Access Compliance Report

Public Rights-of-Way

(Curb Ramps)

Intersection ID: 29171	Main Street: CHIEFTAIN_DR	Cross Street: COUGAR_HILL_CT	Location: SW
ADA ID: 6BFA0561B5FF	Ramp Type: Perp	Initial Pass/Fail: Fail	Overall Compliance: No
Severity Score: 21.25			
Codes/Mitigation Info/Possible Solution		Field Measurements/Component Compliance

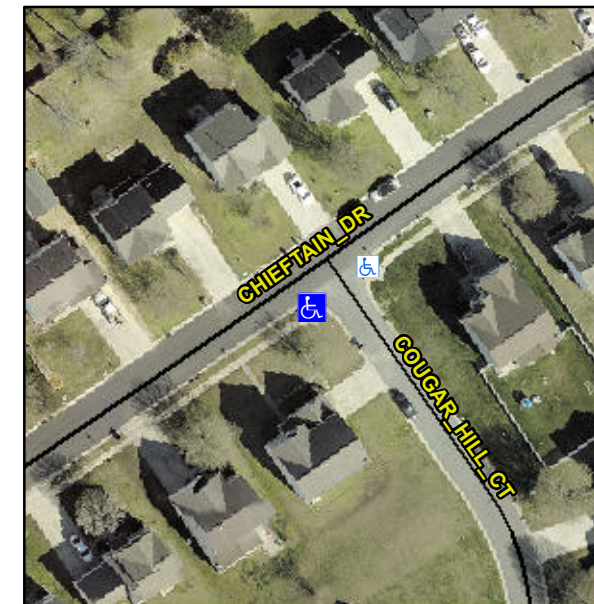
Not Found, R304.5.1, R304.5.3

Compliance	Description	Data	Compliance	Description	Data
N/A	Ramp Length (in)	46.0	Yes	Ramp Slope (%)	5.0
No	Ramp Width (in)	39.5	No	Ramp XSlope (%)	5.5
N/A	Flare Type LT	N/A	N/A	Flare Type RT	N/A
N/A	Flare Slope LT (%)	N/A	N/A	Flare Slope RT (%)	N/A
N/A	Flare Traversable LT?	N/A	N/A	Flare Traversable RT?	N/A
N/A	Landing Length (in)	N/A	N/A	DWS Provided?	N/A
N/A	Landing Width (in)	N/A	N/A	DWS Contrast?	N/A
N/A	Landing Slope (%)	N/A	N/A	DWS Length (in)	N/A
N/A	Landing X Slope (%)	N/A	N/A	DWS Full Width?	N/A
N/A	Landing Curb? (Y/N)	N/A	N/A	DWS Offset (in)	N/A
N/A	Shared Landing?	N/A			
N/A	Gutter Ponding?	N/A	N/A	Gutter Slope (%)	N/A
N/A	Gutter Lip Ht (in)	N/A	N/A	Gutter X Slope (%)	N/A
N/A	Painted X Walk1?	No	N/A	Painted X Walk2?	N/A
	X Walk 1 Direction	To NE		X Walk 2 Direction	N/A
N/A	X Walk 1 Width (in)	N/A	N/A	X Walk 2 Width (in)	N/A
	X Walk 1 Slope (%)	6.9		X Walk 2 Slope (%)	N/A
	X Walk 1 X Slope (%)	1.2		X Walk 2 X Slope (%)	N/A

Remove & Replace Entire Ramp.
